**RE: Administrative Design Review Application Case No. PADR-003473-2024
1325 Opechee Way**

DESIGN REVIEW STAFF REPORT – HILLSIDE SINGLE FAMILY

1325 Opechee Way

ADR-003473-2024

4 REAR ELEVATION - EAST
1/4" = 1'-0"

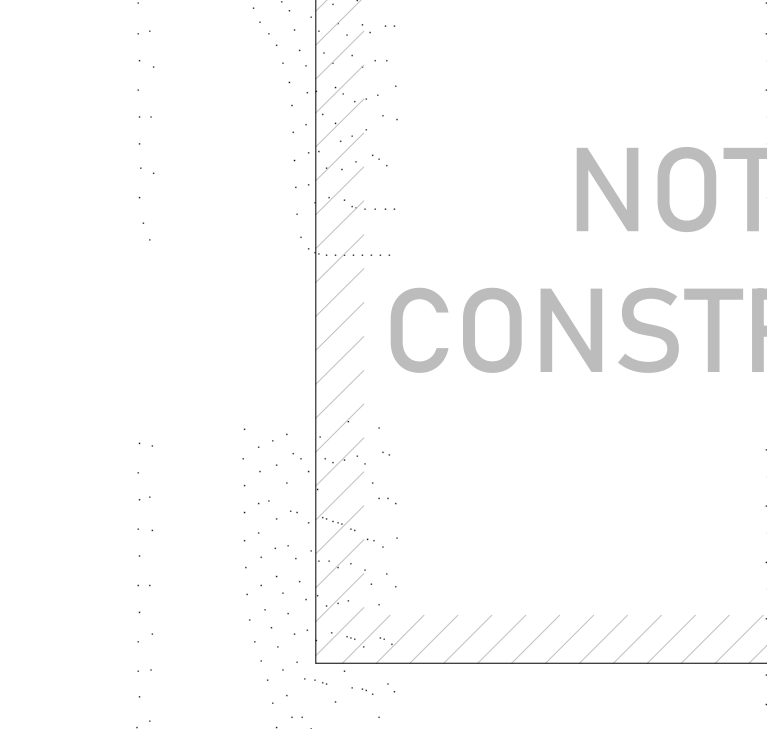
There appears to be stone veneer or cladding, above ground level, visible under ivy plants on current photographs. A condition is included to show this veneer or cladding in revised elevations.

The existing and proposed elevations do not fully show the locations of lighting fixtures, downspouts, vents and utility connections. A condition is included to show, any and all of the following items on the existing and proposed elevations:

1. A revision to the existing and proposed elevations shall be submitted to staff for review and approval prior to plan check submittal. The revision shall include:
 - Any stone veneer or cladding above ground level.
 - Any exterior lighting fixtures, which shall be limited to the main entry, egress door, and vehicle entrance.
 - Any rain gutters and downspouts, which shall match the adjacent wall or roof color and finish.
 - Any vents and utility connections, which shall be integrated into the design while avoiding primary facades.
